United States Patent and Trademark Office

APPLICATION NO.	FILING DATE	FIRST NAMED INVENTOR	ATTORNEY DOCKET NO.	CONFIRMATION NO.
10/724,041	12/01/2003	Martin Leiendecker	A 91874	1537
75	90 07/14/2006		EXAMINER	
Walter Ottesen			CADUGAN, ERICA E	
Patent Attorney	•		ART UNIT PAPER NUMBER	
P.O. Box 4026			3722

DETAILED ACTION

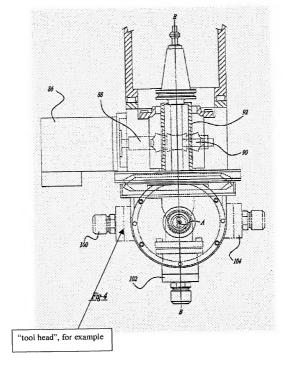
Cardenas teaches a multi-axis machining head including a "tool holder" (including at least member 22) that has a tool mounting portion 44 for mounting a milling tool 18 located at a free end thereof. The "tool holder" (including at least element 22) is rotatable about a vertical "rotational axis" B via motor 86 (see Figures 3-4 and col. 4, lines 5-11, for example).

Additionally, the cutting tool 18 is rotatable about axis A via motor 48 (see Figures 3-4 and col. 3, lines 10-14, for example), which is orthogonal to the vertical rotational axis B. Note that this rotation about axis A provides at least positions 100 and 104 wherein the central longitudinal rotational axis of the cutting tool bit 18 is orthogonal to the rotational axis B. Note also that Cardenas explicitly teaches that the tool is moved in X, Y, and Z directions (shown in Figures 1-2, see also col. 4, lines 16-24, for example), and thus, the tool can be moved in a direction

Re claim 7, for example, see the reproduction of Figure 4 below.
